RE: Holcim Quincy Pit, Permit; M2000080
TR3 Preliminary Adequacy

Pioneer Farm Pit (Quincy)

M-2000-080

Re: Permit No. M-2000-080 – Pioneer Farm Pit (Quincy)
Technical Revision Request 3 (TR-03) Preliminary Adequacy Response

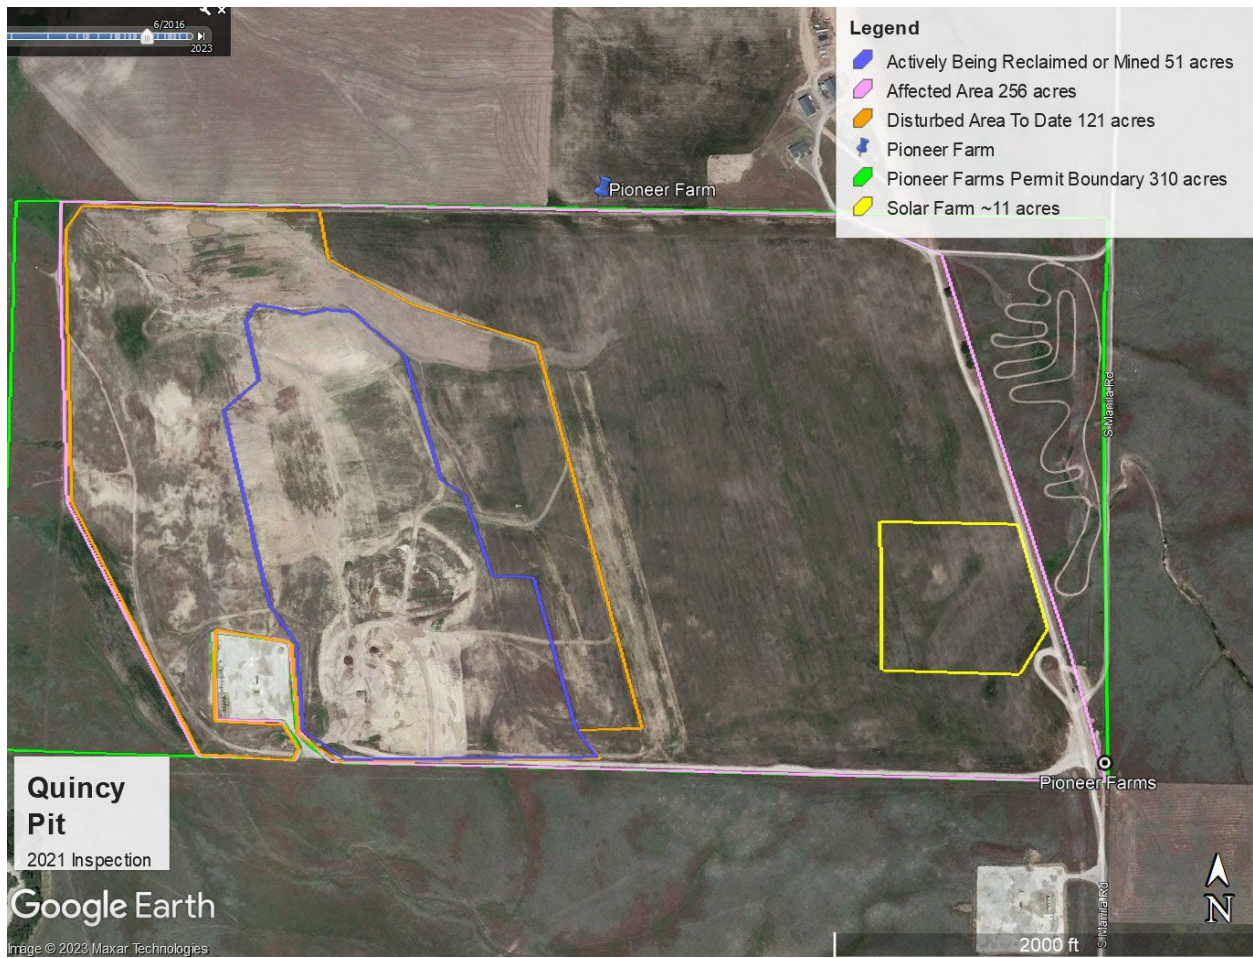
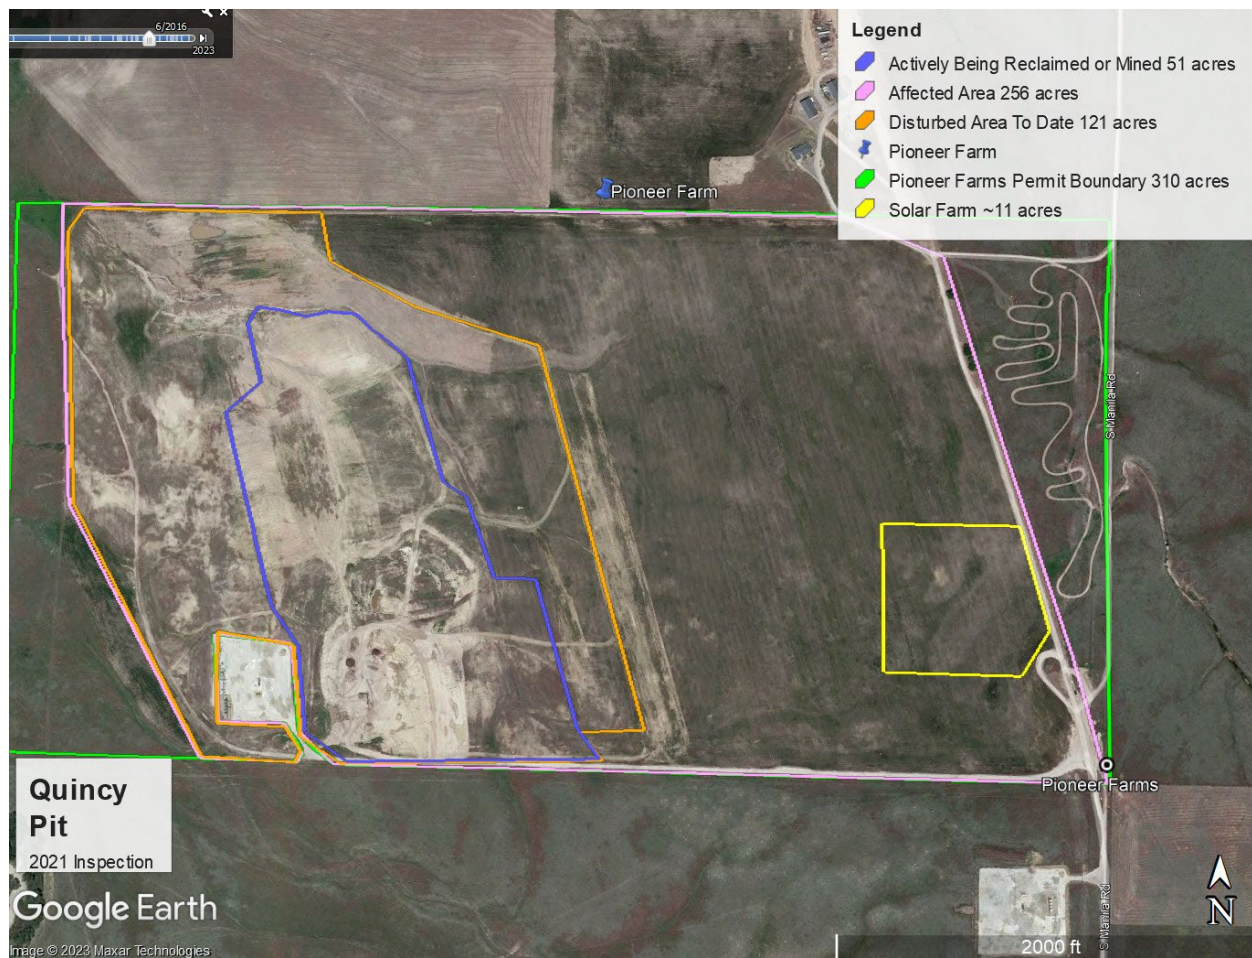
There appears to be a discrepancy between the map submitted the approved mine plan map of 2021 and historic imagery as viewed on Google Earth. The approved mine plan map appears to be in error as historic imagery indicates the north area of 67 acres designated as reclamation has never been disturbed by mining. This area appears to have been continuously cropped.

1. Please review the attached images and update the mine plan map as follows:

Correct the acreages for:

- Active reclamation*
- Affected area*
- Disturbed acres to date*
- Completed reclamation*
- Solar farm*
- Stripping proposed*

2. Please add to the Mining and Reclamation Plan Map the location and associated acreage of the solar farm.

3. DRMS is unclear what is meant by active area. Please clarify by explaining what activities are occurring in the active area.

- Completed reclamation acreage has increased to ~49.4 acres.
- Active reclamation acreage ~0.0 acres.
- Disturbed acres (reclaimed + active) to date ~110.0 acres.
- Current active stripping/mining acreage has increased to ~60.6 acres.
- Current DRMS Permit Boundary remains the same at ~310.0 acres.
- Holcim anticipates 2024 stripping/mining activities to include ~15.3 acres.
- Solar Farm ~10.0 acres.
- Affected area ~242.0 acres.

Active area is defined as areas that are being currently mined to include stripping and screening of material.
